1956 Corvette Service Bulletin: Clutch Disc - Springs - Periodic Vibration

Bulletin No: DR #266

Date: October 5, 1956

Figure 1
1956 CLUTCH IDENTIFICATION

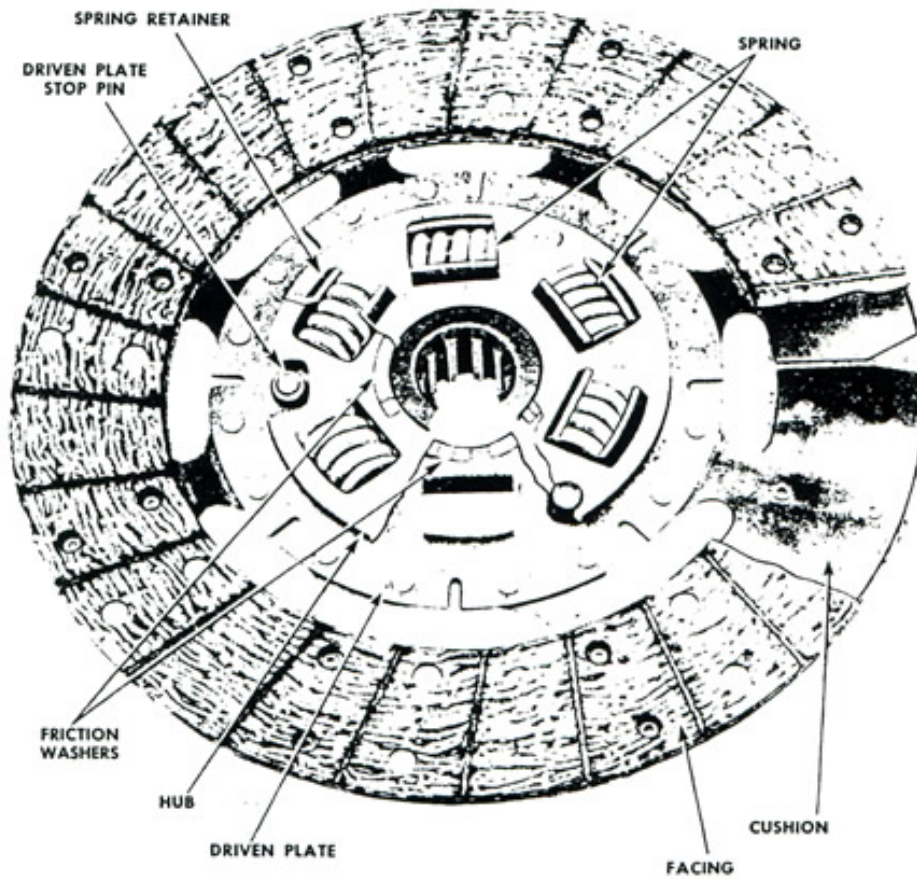
To control periodic vibration as outlined above, dampers are incorporated in the clutch disc assemblies, Figure 1 on page 2 shows cutout illustration of the construction of a clutch disc assembly. The number of coil springs, size, and other details, will vary in some discs; however, this is a typical example.

One-piece friction washers are also installed on both sides of the driven plate hub. These create friction between the moving parts of the assembly, this friction is predetermined and is maintained in production to make the assembly function properly.

It is important to keep transmission lubricant or any other lubricant out to prevent any variation in friction which will change the tuning characteristics of the assembly and permit periodic vibration.

IMPORTANT that the clutch disc assembly be replaced using a new clutch disc as listed in the chart for that particular model. Make sure there is no grease on the new clutch disc hub and dampers or the transmission main drive gear splines. If grease is present on the splines, the main drive gear bearing retainer should be corrected as necessary.

Unit should be drive at least 25 miles to stabilize friction lag in the new clutch disc.
